3/31/09	Added General Note (F)
DATE	REVISION	
STATE OF HAWAII DEPARTMENT OF TRANSPORTATION HIGHWAYS DIVISION BRIDGE GENERAL NOTES INTERSTATE ROUTE H-1 EXTENSION AND REPAIR OF SCHOOL STREET ON-RAMP RETAINING WALL Project No. H11-01-08 Scale: As Noted Date: Feb., 2009

3/31/09	Revised and/or Added Callouts and Legend
DATE	REVISION
STATE OF HAWAII DEPARTMENT OF TRANSPORTATION HIGHWAYS DIVISION RETAINING WALL REPAIR and EXTENSION EXISTING SITE PLAN INTERSTATE ROUTE H-1 EXTENSION and REPAIR of SCHOOL STREET ON-RAMP RETAINING WALL Project No. H11-01-08	
Scale: As Noted	Date: Feb, 2009
SHEET No. Q3 OF 34 SHEETS

RETAINING WALL REPAIR and EXTENSION

TIEBACK ANCHOR PLACEMENT DETAILS

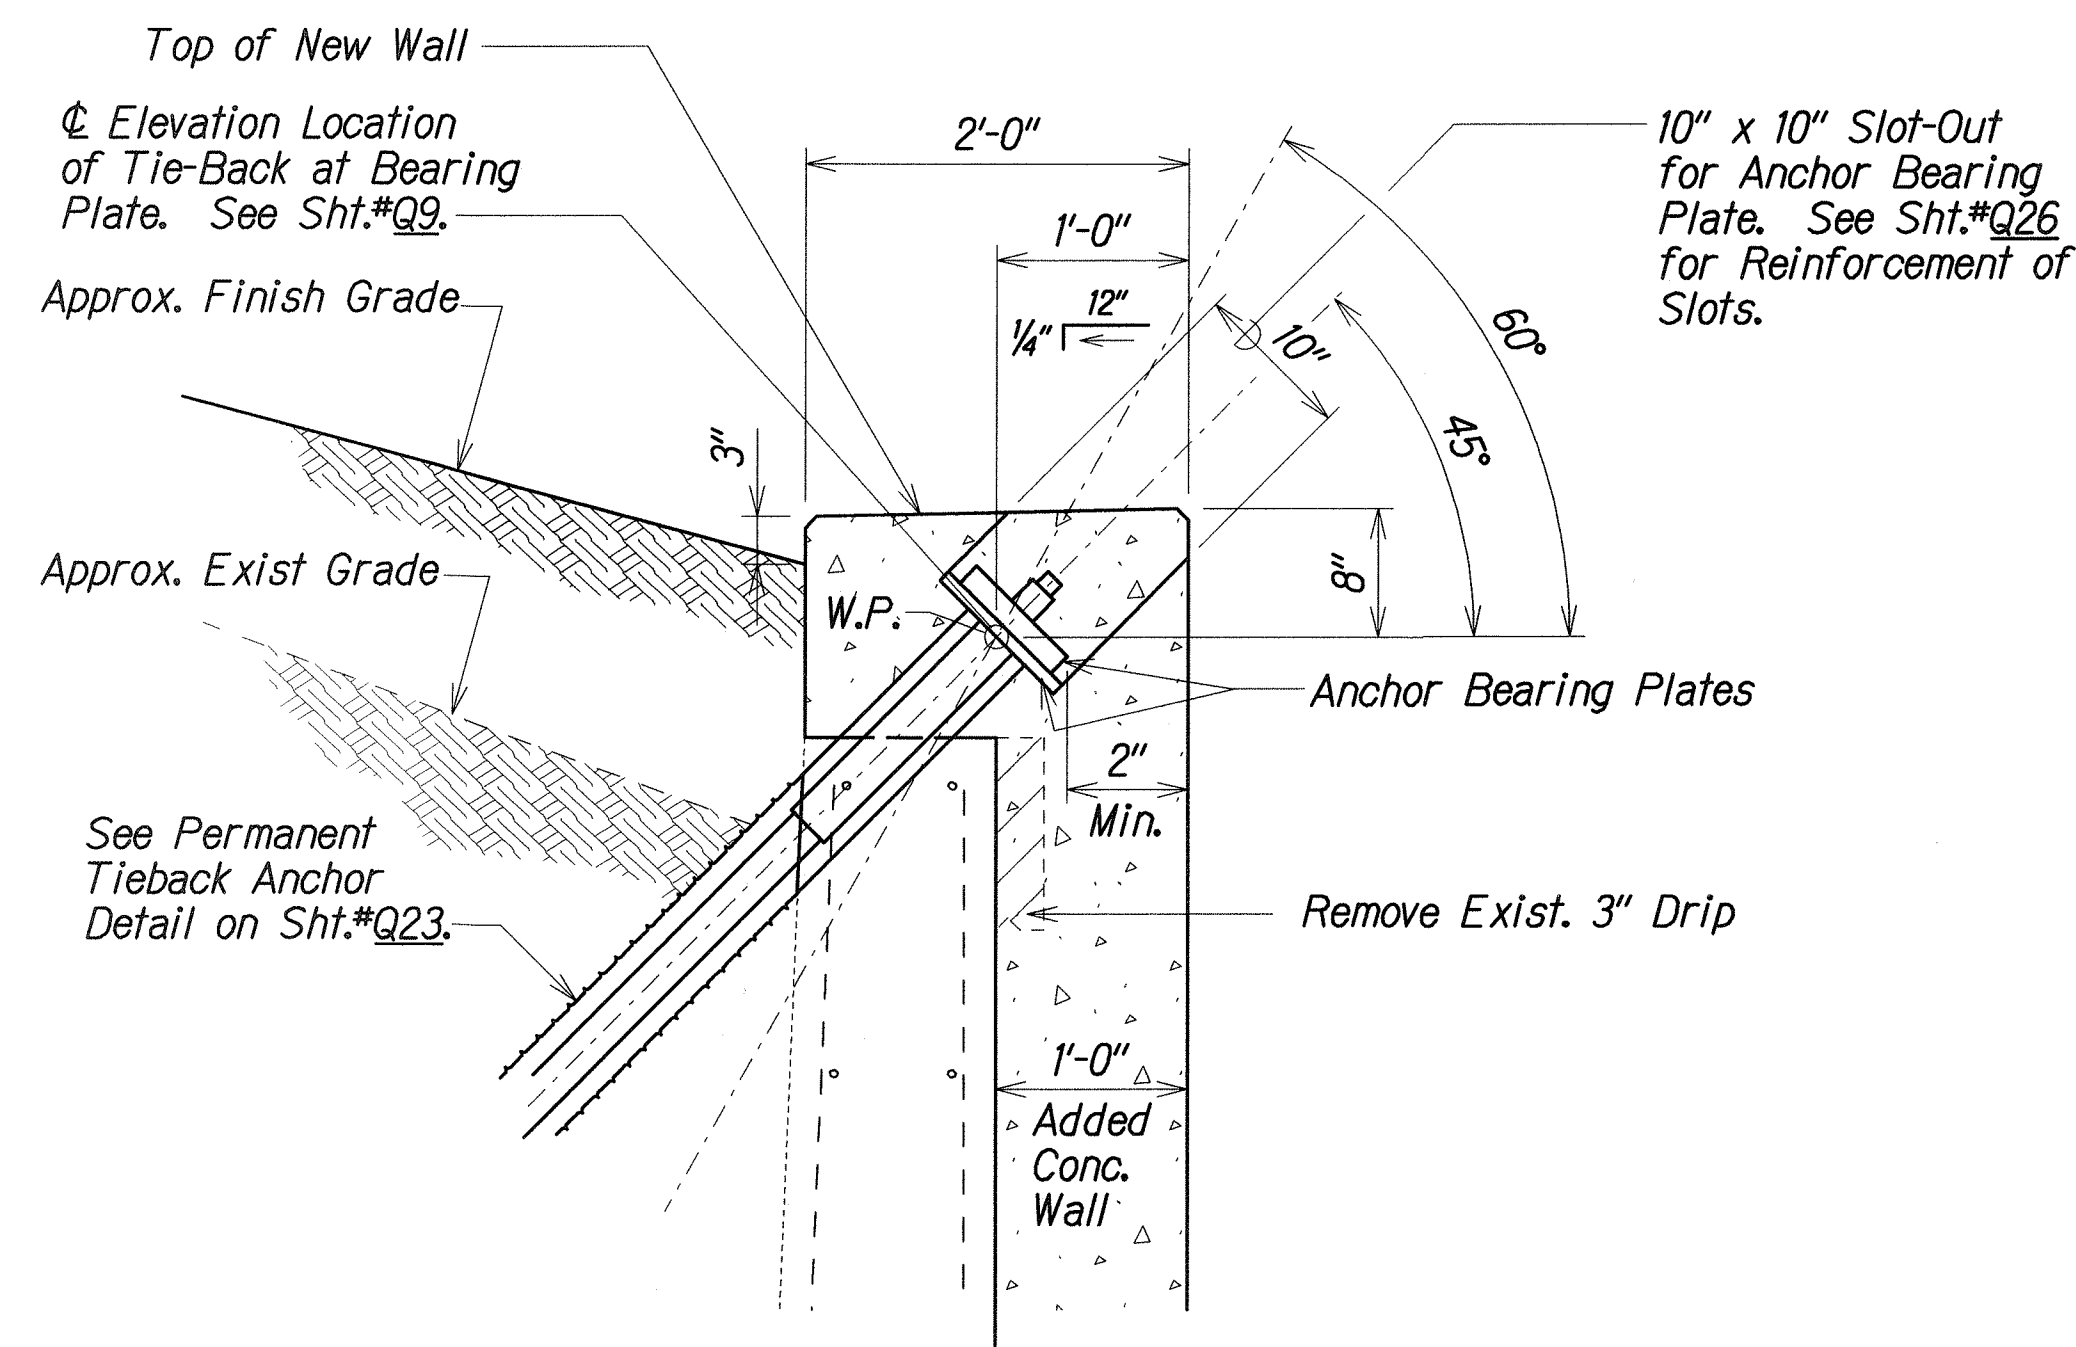
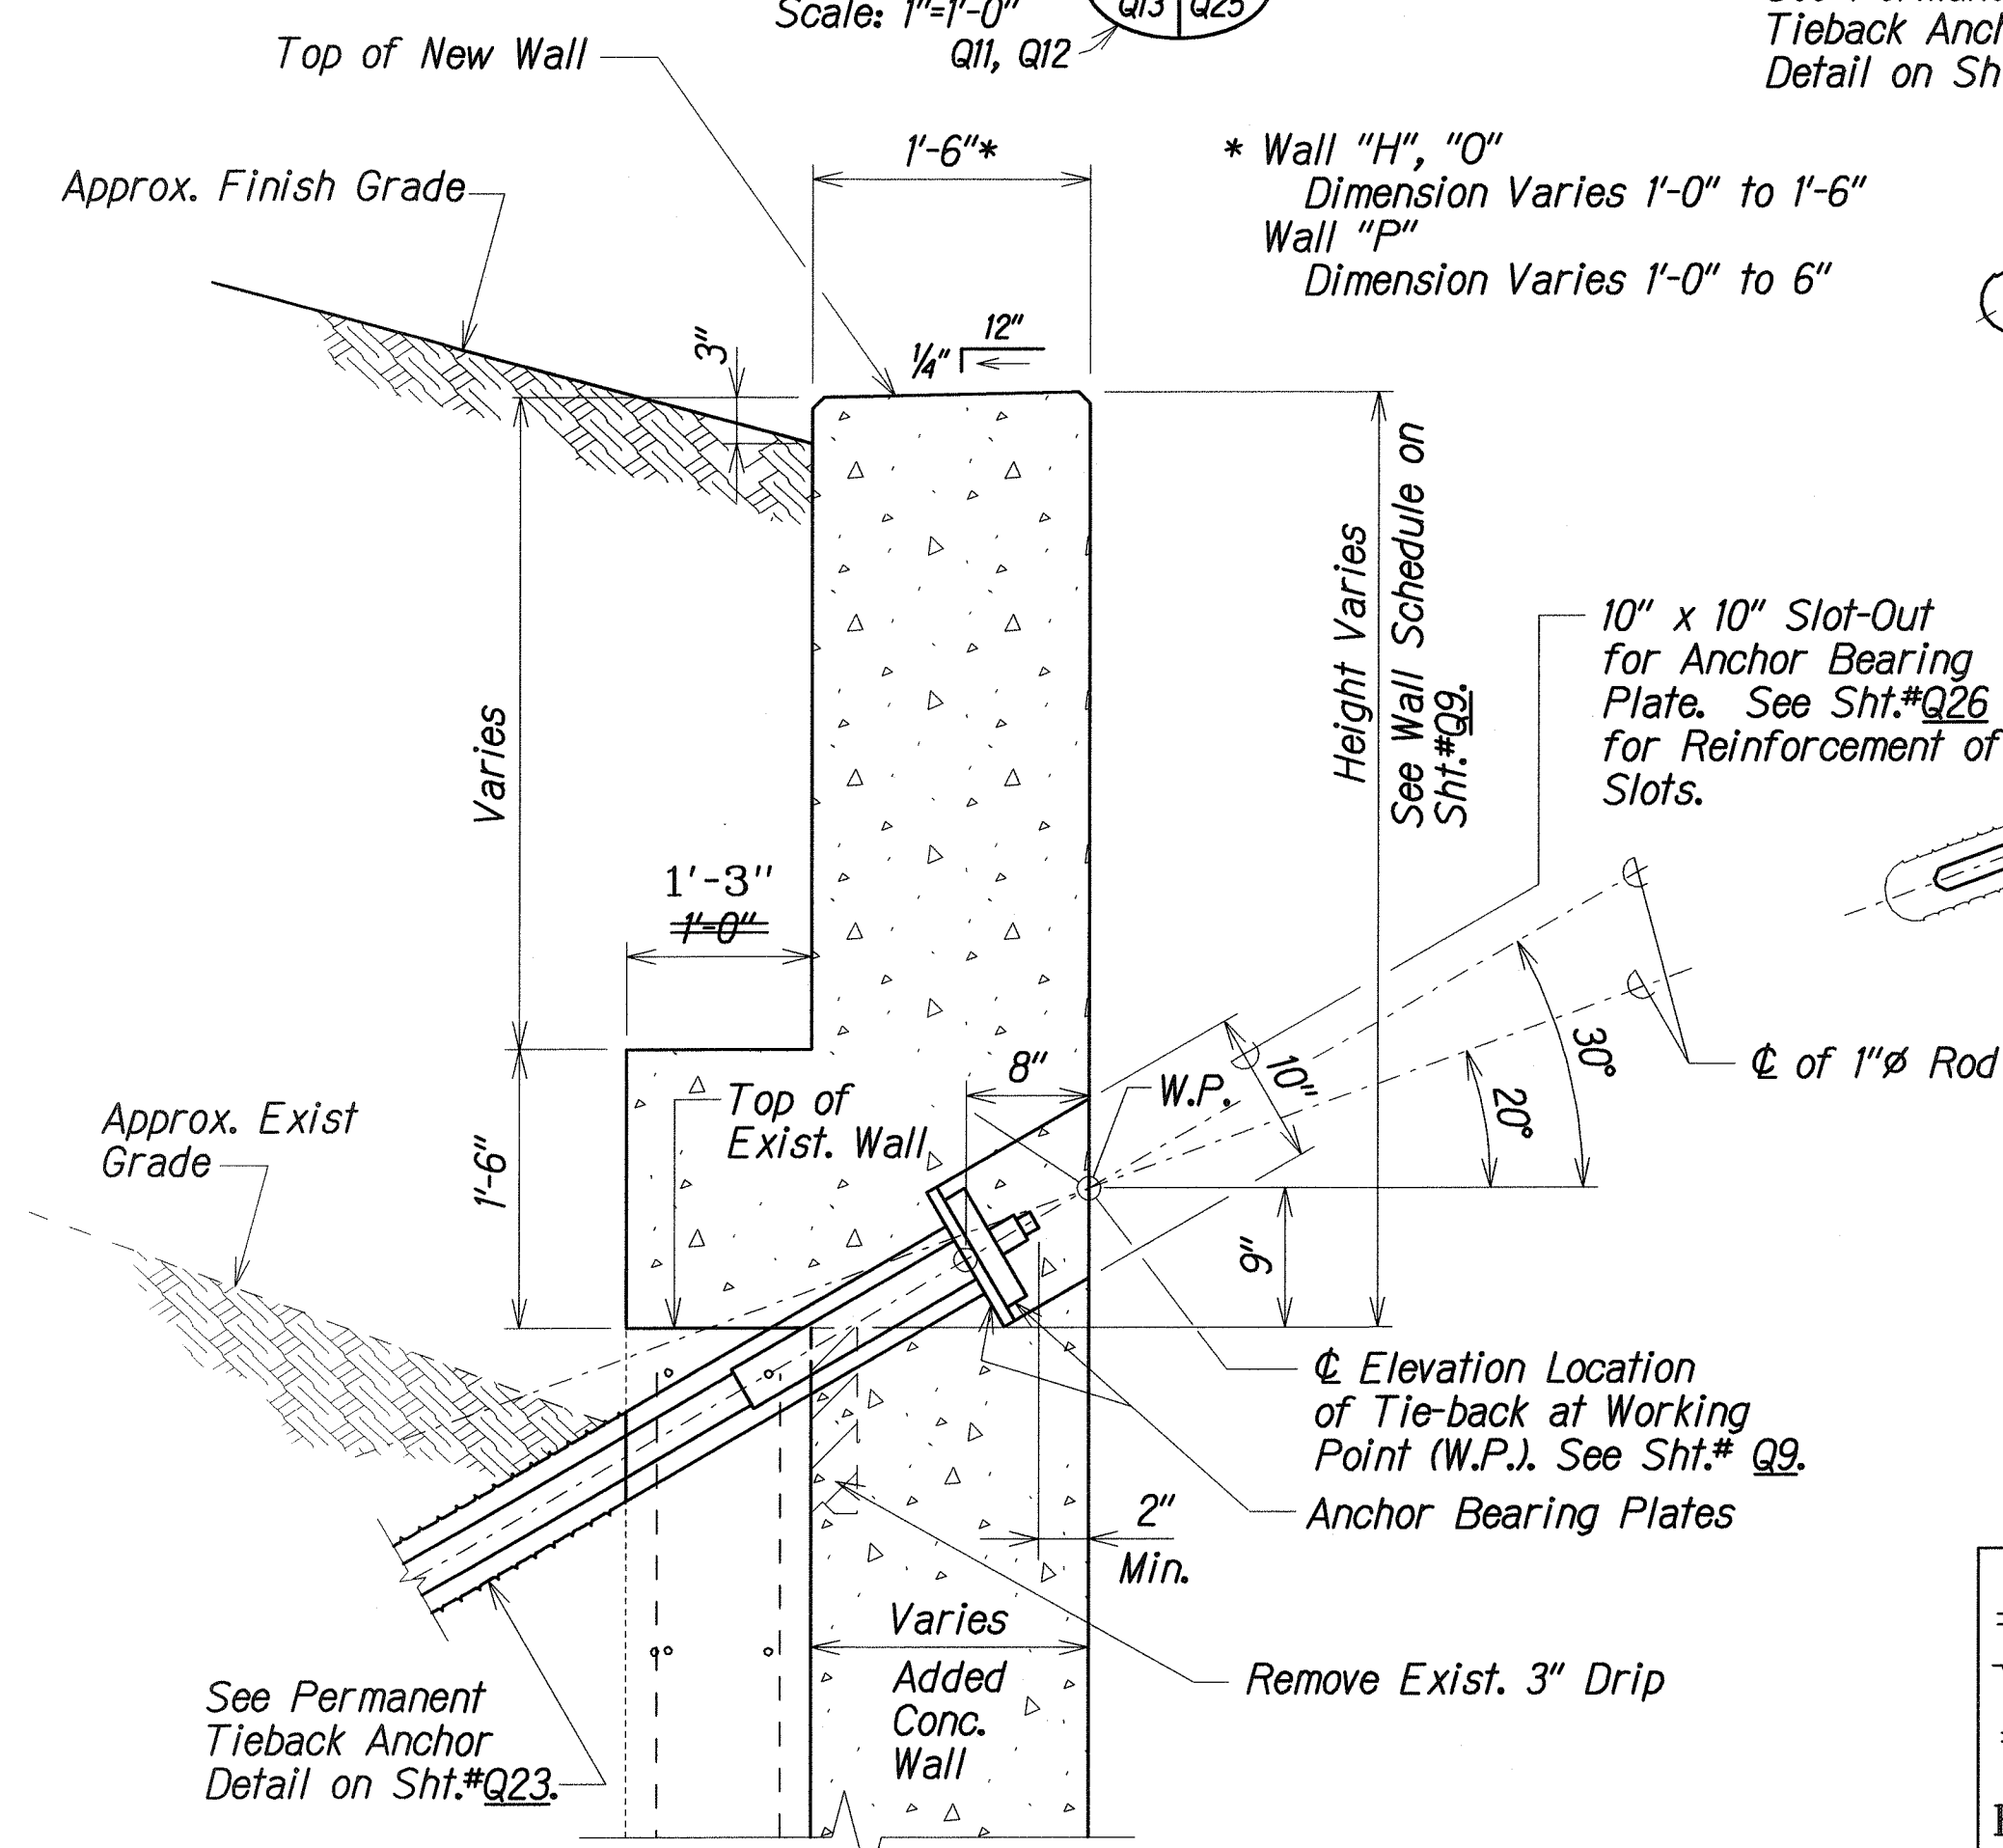
Added Note No. 2 for Walls K, L & M. Added Sheet Number to Section Symbol	8/17/09
DATE	REVISION
	STATE OF HAWAII DEPARTMENT OF TRANSPORTATION HIGHWAYS DIVISION
	RETAINING WALL REPAIR TIEBACK ANCHOR PLACEMENT DETAIL INTERSTATE ROUTE H-1 EXTENSION AND REPAIR OF SCHOOL STREET ON-RAMP RETAINING WALL Project No. H11-01-08
Scale: As Noted	Date: Feb, 2009
SHEET No. Q25 OF 34 SHEETS

- NOTES:
- After Anchors have been Proof Tested and Lockoff Loads Applied, Reinforce Slot and Seal with Concrete, similar in Strength and Texture to Added Wall Concrete. Appearance shall be acceptable to the Engineer with no tell tales of Slot-Outs.
 - For Distressed Walls K, L & M, Refer Sht.#Q25A.
 - * See Det. 2 for dimensions.
